Access Compliance Report Public Rights-of-Way (Curb Ramps)

Intersection ID: 27456 Main Street: BALLANTYNE_MEADOWS_DR Cross Street: GRAHAMWOOD_PL Location: S

ADA ID: D4EDD8896AAF Ramp Type: PerpDiag Initial Pass/Fail: Fail Overall Compliance: No Severity Score: 25

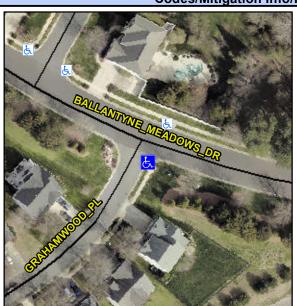
PROW/ADA:
R304.5.3

Field Measurements/Component Compliance					
Compliance Description		Data	Compliance Description		Data
N/A	Ramp Length (in)	48.0	Yes	Ramp Slope (%)	7.0
Yes	Ramp Width (in)	48.0	No	Ramp XSlope (%)	8.′
N/A	Flare Type LT	N/A	N/A	Flare Type RT	N/A
N/A	Flare Slope LT (%)	N/A	N/A	Flare Slope RT (%)	N/A
N/A	Flare Traversable LT?	N/A	N/A	Flare Traversable RT?	N/A
N/A	Landing Length (in)	N/A	N/A	DWS Provided?	N/A
N/A	Landing Width (in)	N/A	N/A	DWS Contrast?	N/A
N/A	Landing Slope (%)	N/A	N/A	DWS Length (in)	N/A
N/A	Landing X Slope (%)	N/A	N/A	DWS Full Width?	N/A
N/A	Landing Curb? (Y/N)	N/A	N/A	DWS Offset (in)	N/A
N/A	Shared Landing?	N/A			
N/A	Gutter Ponding?	N/A	N/A	Gutter Slope (%)	N/A
N/A	Gutter Lip Ht (in)	N/A	N/A	Gutter X Slope (%)	N/A
N/A	Painted X Walk1?	No	N/A	Painted X Walk2?	No
	X Walk 1 Direction	To NE		X Walk 2 Direction	To NV
N/A	X Walk 1 Width (in)	N/A	N/A	X Walk 2 Width (in)	N/A
	X Walk 1 Slope (%)	5.1		X Walk 2 Slope (%)	2.4

Remove & Replace Curb Ramp With
Two New Directional Ramps or
Equivalent.
